SUNDRY NOTICES AND REPORTS ON WELLS

SUBJECT Plug & Abandon The Rincon Unit Well No. 28	W O / A . F . E . NO
---	----------------------

Attachment to Notice of
Intention to Abandon

Well: 28 Rincon Unit

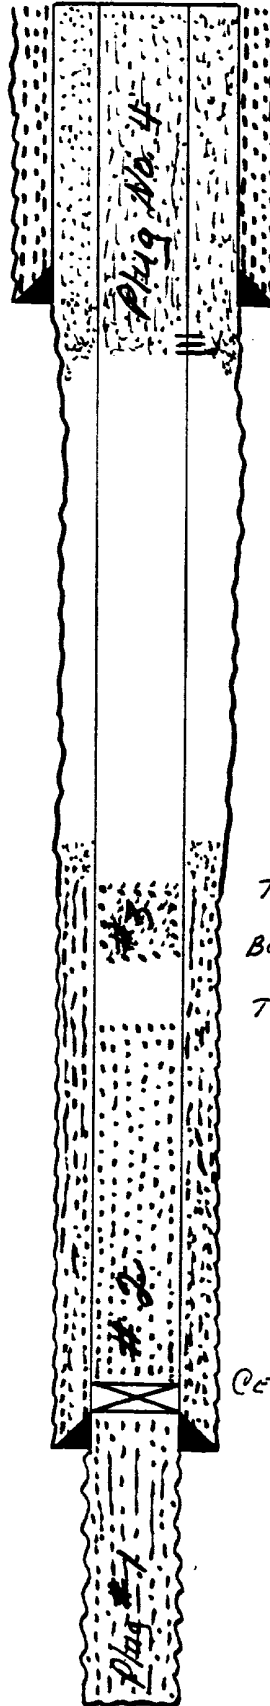
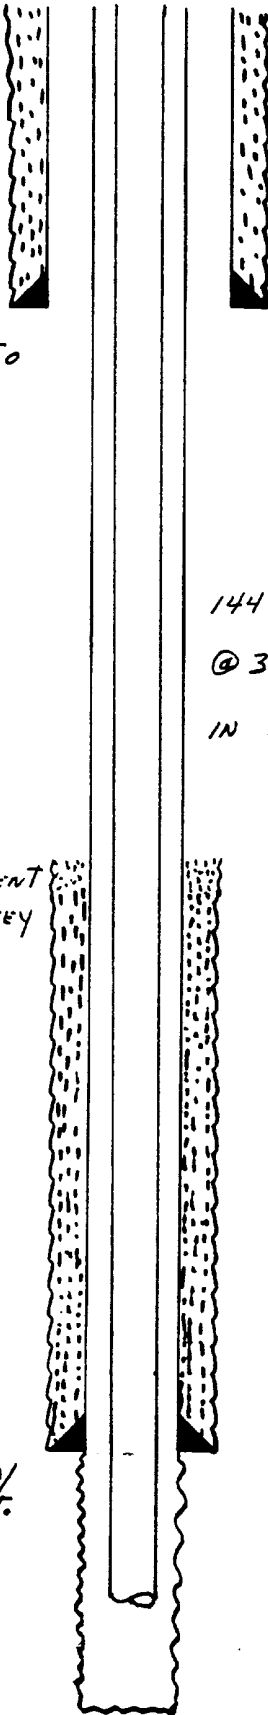
4. The following modifications to your plugging program are to be made (when applicable):

Add a plug from 1534-1434 inside & outside 5 1/2" casing 648X
